# Service Bulletin

Horizontal Stabiliser Aft Pivot Modification

Document: Service Bulletin SB-GA8-2005-21

**Figure 1: Finished modified pivot installation (looking from inside the aft fuselage).**

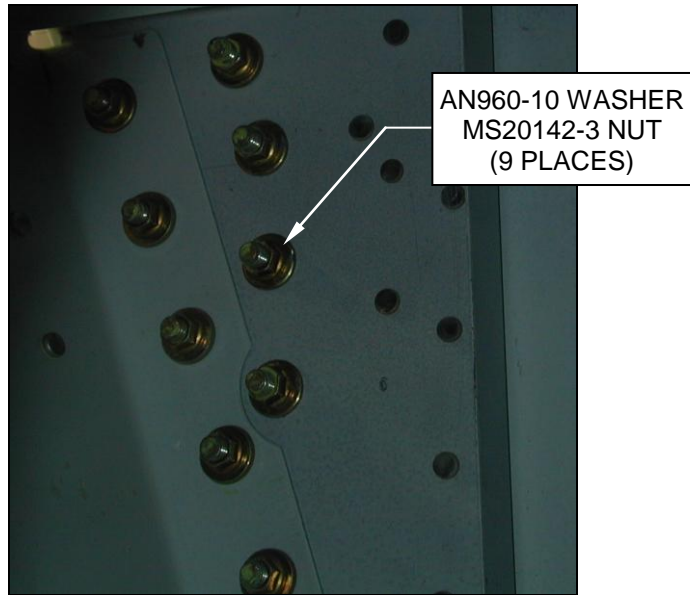
6. Drill a lubrication hole with diameter  $0.078" \pm 0.005"$  ( $1.984 \pm 0.127$  mm) in the pivot brackets as per figure 4, and chamfer the outer edge of the hole  $0.05" \pm 0.005"$  ( $1.27 \pm 0.127$  mm) with a  $45^\circ$  countersink.
7. Install the brackets using items 3, 4, 6, and 8 as per figures 1 and 2. Pack bolt threads with thin washer (item 4) under the bolt head, and a washer (item 3) under the nut (item 6).
8. Attach the stabiliser aft pivot channel mount to the fuselage pivot bracket using items 1, 2, 5, 7 and 9 as per figures 2 and 3.
9. Lubricate the bushes using general-purpose grease through the lubrication holes in the brackets.
